UNITED STATES PATENT AND TRADEMARK OFFICE

APPLICATION NO.	FILING DATE	FIRST NAMED INVENTOR	ATTORNEY DOCKET NO.	CONFIRMATION NO.
10/702,505	11/07/2003	Hae Wook Kwon	P24431	8513
7055	7590	12/12/2005	EXAMINER	
GREENBLUM & BERNSTEIN, P.L.C.			TO, TOAN C	
1950 ROLAND CLARKE PLACE			ART UNIT	
RESTON, VA 20191			PAPER NUMBER

Office Action Summary	Application No. 10/702,505	Applicant(s) KWON, HAE WOOK	
	Examiner Toan C. To	Art Unit 3616

FIG. 3(Prior Art)

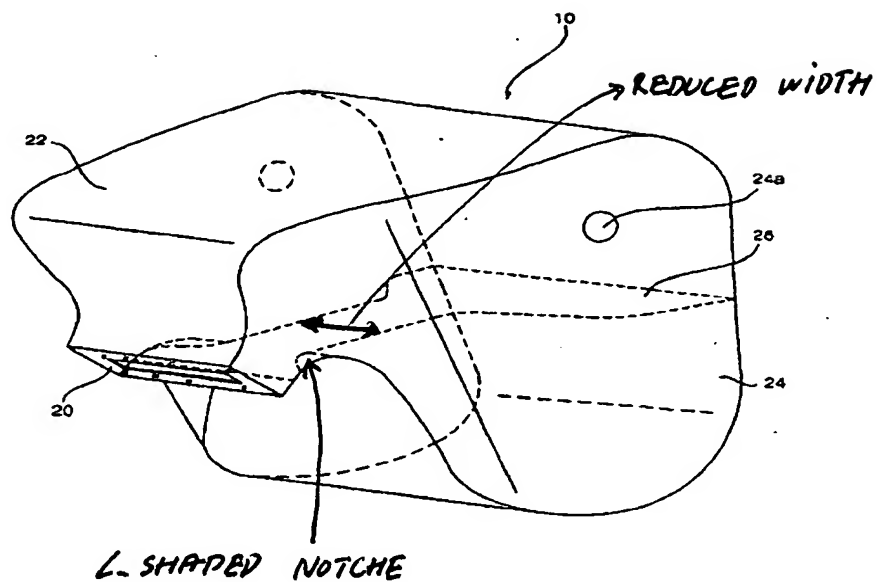
5. Claims 1-10 are rejected under 35 U.S.C. 102(b) as being anticipated by Prior art figures 1-4 of the instant application.

Prior art figures 1-4 disclose a cushion for an air bag system, the air bag system including a cushion expanded to the front of a passenger by means of gas discharged from an inflator when a collision of the vehicle occurs for absorbing shock transmitted to the passenger, wherein the cushion comprises: a main panel (22) having an inlet part (20) formed at one side thereof for allowing the gas discharged from the inflator to be introduced into the cushion therethrough; side panels (24) attached to both open sides of the main panel by means of sewing, respectively; and a tether (26) having one end fixed to the inlet part (20) of the main panel (22) by means of sewing and the other end fixed to the inner side of the panel opposite to the inlet part of the main panel while not

intersecting with the parts where the main panel and the side panels (24) are sewn; wherein one end of the tether (26) is fixed to the main panel (22) so that the tether (26) forms the inlet part together with the main panel (page 5, lines 15-17 of the instant specification); wherein the tether (26) is sewn to a first sewing part (28) sewing the main panel (22) and the side panels (24) at both sides of one end thereof, and wherein a second sewing part (30) sewing the end of the tether to the main panel is formed such that the first and second sewing parts intersect each other (A); wherein the tether (26) has notches formed at both sides of one end thereof where the second sewing part (30) is formed; wherein the notches are formed at both sides of one end of the tether with steps such that the width of the tether is reduced; wherein the end of the tether is disposed between the parts where the first and second sewing parts intersect each other; wherein the notches are formed with L-shaped steps; wherein the stepped parts are rounded; wherein the tether has wing parts formed at both sides of one end of the tether such that the wing parts cover the first sewing part 58 at the inlet part (see prior art figures 3-4 below for examiner's interpretation).
